# SERVICE LETTER

No. 596A

Piper Aircraft Corporation

Subject: Nose Landing Gear System Product Advancement Information.

NOSE GEAR STRUT ASSEMBLY

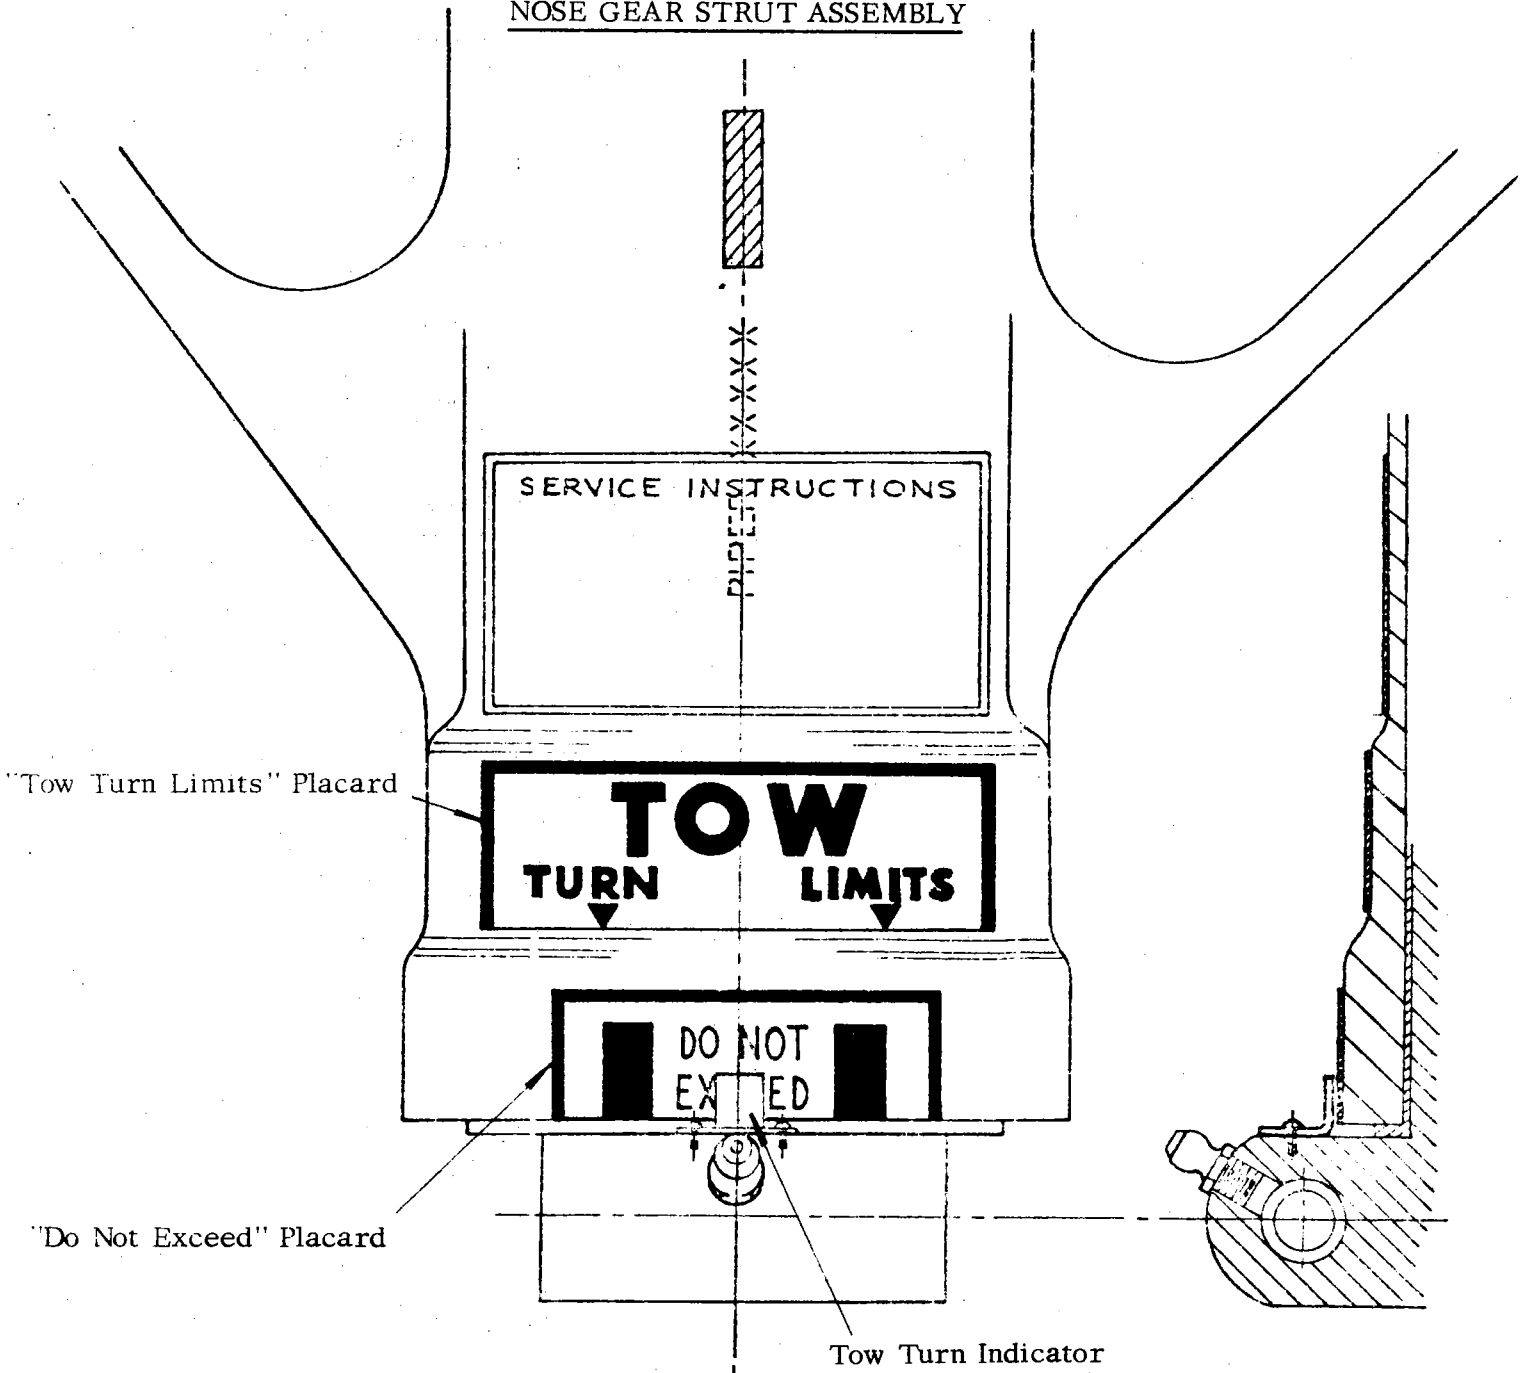
1. Nose Gear Aligner Guide Bracket Assembly - applies to all aircraft specified in Material Required No. 1, below:
  - a. Inspect existing Nose Gear Aligner Guide Bracket; if guide channel material thickness is .062", replace with new Aligner Guide Bracket Assembly, part number 21719-11. NOTE: It is recommended that the new Aligner Guide Bracket be installed using the new "High Strength" Attachment Bolts, specified below. Prior to installation, check attachment bolt hole size (in Aligner Guide Bracket) to insure .202" diameter, as shown on top portion of attached sketch. .204

- b. If existing Aligner Guide Bracket channel material thickness is .095", remove, ream attachment bolt hole size to .202" diameter (as shown on top portion of attached sketch) .204 and reinstall using new "High Strength" bolts.

- (1.) PA-24-260, serial numbers 24-4980 to 24-4983 inclusive, 24-4985, 24-4986, 24-4988 to 24-5047 inclusive.
    - (2.) PA-39, serial numbers 39-114 to 39-117 inclusive, 39-119 to 39-121 inclusive, and 39-123 to 39-127 inclusive, 39-129 and 39-131.Remove the Aligner Guide Bracket Assembly, ream attachment bolt hole size to .202" diameter, and reinstall using "High Strength" attachment bolts. .204

Replace Existing Bolts with High Strength Bolts - P/N 402 800 (NAS 1303-8H) (3 Req'd.) Torque 30-35 in. lbs.

Drill and Ream Holes .202 / .204 Diameter
